APPLICATION NO.	FILING DATE	FIRST NAMED INVENTOR	ATTORNEY DOCKET NO.	CONFIRMATION NO.
10/781,505	02/18/2004	Rafail Zubok	532-3X6	2913
530 7590 03/12/2007 LERNER, DAVID, LITTENBERG, KRUMHOLZ & MENTLIK 600 SOUTH AVENUE WEST WESTFIELD, NJ 07090			EXAMINER CUMBERLEDGE, JERRY L	
			ART UNIT 3733	PAPER NUMBER
SHORTENED STATUTORY PERIOD OF RESPONSE			MAIL DATE	
3 MONTHS			03/12/2007	
			DELIVERY MODE PAPER

Office Action Summary

DETAILED ACTION

**Fig. 13****Fig. 14a****Fig. 14b**

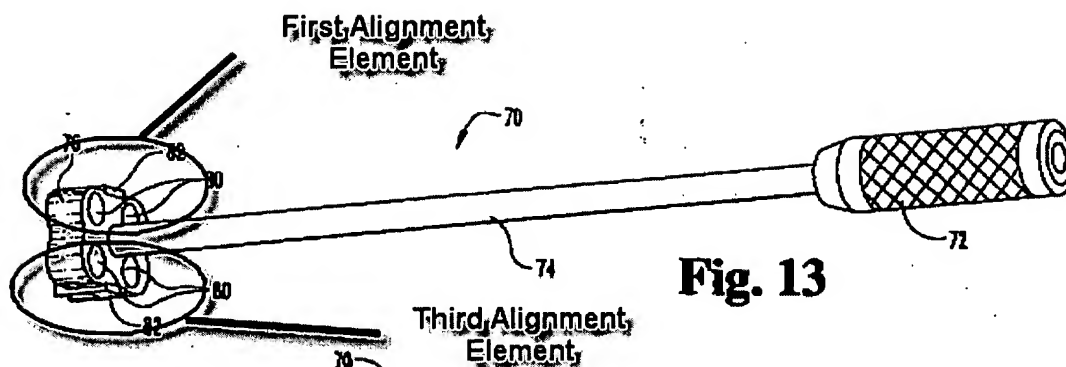
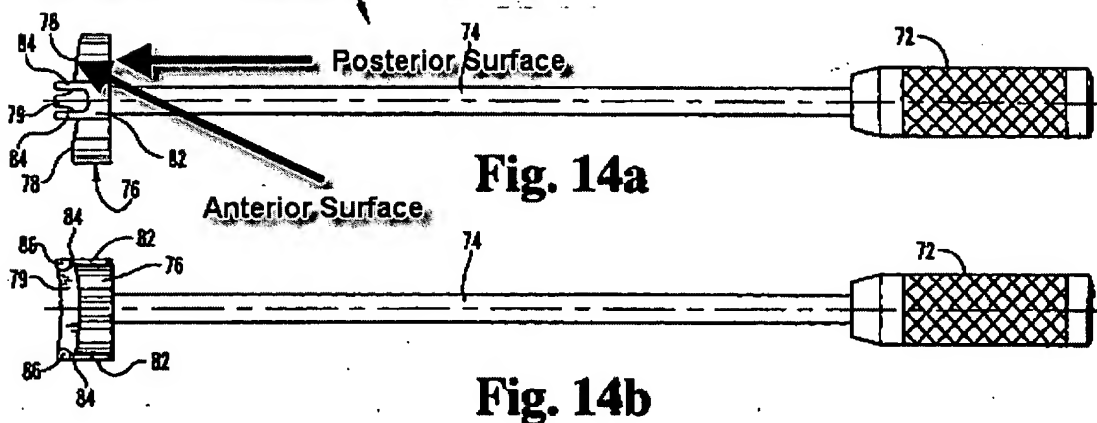
Gill et al. disclose a drill guide, comprising: a shaft (Fig. 13, ref. 74) having a proximal end (Fig. 13, end ref 72) and a distal end (Fig. 13, end near ref. 76); and a guide member (Fig. 13, ref. 76) disposed at the distal end of the shaft and operable to engage an insertion plate that maintains first and second members of an intervertebral disc replacement device in registration with one another for insertion into an intervertebral disc space of a spinal column, wherein the guide member includes at least one guide bore (Fig. 13, ref. 80) operable to align with an area of a vertebral bone

of the intervertebral disc space to which one of the first and second members of the intervertebral disc replacement device is to be attached. The guide member includes a first alignment element (Fig. 13, remarked, below) operable to engage a second alignment element of the insertion plate and to enable a target orientation of a longitudinal axis of the guide bore relative to at least one of the vertebral bone and the one of the first and second members of the intervertebral disc replacement device. The first alignment element of the guide member includes an alignment stem (Fig. 14a, ref. 84). The guide bore is disposed at least partially through the third alignment element (Fig. 13, remarked, below) such that the target orientation of the longitudinal axis of the guide bore is directed through the at least one through hole. The guide member includes a posteriorly directed surface (Fig. 14a, remarked, below) and a spaced apart anterior directed surface (Fig. 14a, remarked, below); the first alignment element of the guide member includes the alignment bore extending from the posteriorly directed surface at least partially through the guide member toward the anteriorly directed surface (Fig. 13, below). The alignment bore has a longitudinal axis that is offset from a longitudinal axis of the shaft (Fig. 13). The guide member includes at least two guide bores (Fig. 13, ref. 82).

Gill et al. disclose a drill guide, comprising: a shaft (Fig. 13, ref. 74) having a proximal end (Fig. 13, end ref 72) and a distal end (Fig. 13, end near ref. 76); and a guide member (Fig. 13, ref. 76) disposed at the distal end of the shaft and including at least one guide bore (Fig. 13, ref. 80), the guide member being operable to engage an insertion plate that maintains first and second members of an intervertebral disc

replacement device in registration with one another for insertion into an intervertebral disc space of a spinal column, wherein: the guide member is operable to achieve at least first and second alignment modes with respect to the insertion plate, in the first alignment mode, the guide member is operable to engage the insertion plate such that the at least one guide bore aligns with an area of a first vertebral bone of the intervertebral disc space to which one of the first and second members of the intervertebral disc replacement device is to be attached, and in the second alignment mode, the guide member is operable to engage the insertion plate such that the at least one guide bore aligns with an area of a second vertebral bone of the intervertebral disc space to which the other of the first and second members of the intervertebral disc replacement device is to be attached. The guide member includes a first alignment element (Fig. 13, remarked, below) operable to variably engage a second alignment element of the insertion plate to achieve the first and second alignment modes; in the first alignment mode, the first alignment element of the guide member is operable to engage the second alignment element of the insertion plate to enable a first target orientation of a longitudinal axis of the guide bore relative to at least one of the first vertebral bone and the first member of the intervertebral disc replacement device; and in the second alignment mode, the first alignment element of the guide member is operable to engage the second alignment element of the insertion plate to enable a second target orientation of the longitudinal axis of the guide bore relative to at least one of the second vertebral bone and the second member of the intervertebral disc replacement device. One of the first alignment element of the guide member and the

second alignment element of the insertion plate includes an alignment stem (Fig. 14a, ref. 84). The guide member of the drill guide further includes at least a third alignment element (Fig. 13, remarked, below) operable to: (i) engage the at least one through hole of the first flange when the alignment stem is received within the alignment bore in the first alignment mode to further enable the first target orientation of the longitudinal axis of the guide bore, and (ii) engage the at least one through hole of the second flange when the alignment stem is received within the alignment bore in the second alignment mode to further enable the second target orientation of the longitudinal axis of the guide bore. The guide bore is disposed at least partially through the third alignment element (Fig. 13, remarked, below) such that the target orientations of the longitudinal axis of the guide bore may be directed through the respective through holes in the first and second alignment modes. The guide member includes a posteriorly directed surface (Fig. 14a, remarked, below) and a spaced apart anterior directed surface (Fig. 14a, remarked, below); the first alignment element of the guide member includes the alignment bore extending from the posteriorly directed surface at least partially through the guide member toward the anteriorly directed surface (Fig. 13); and the second alignment element of the insertion plate includes the alignment stem extending in an anterior direction for engagement with the alignment bore (Fig. 13). The alignment bore has a longitudinal axis that is offset from a longitudinal axis of the shaft (Fig 13).
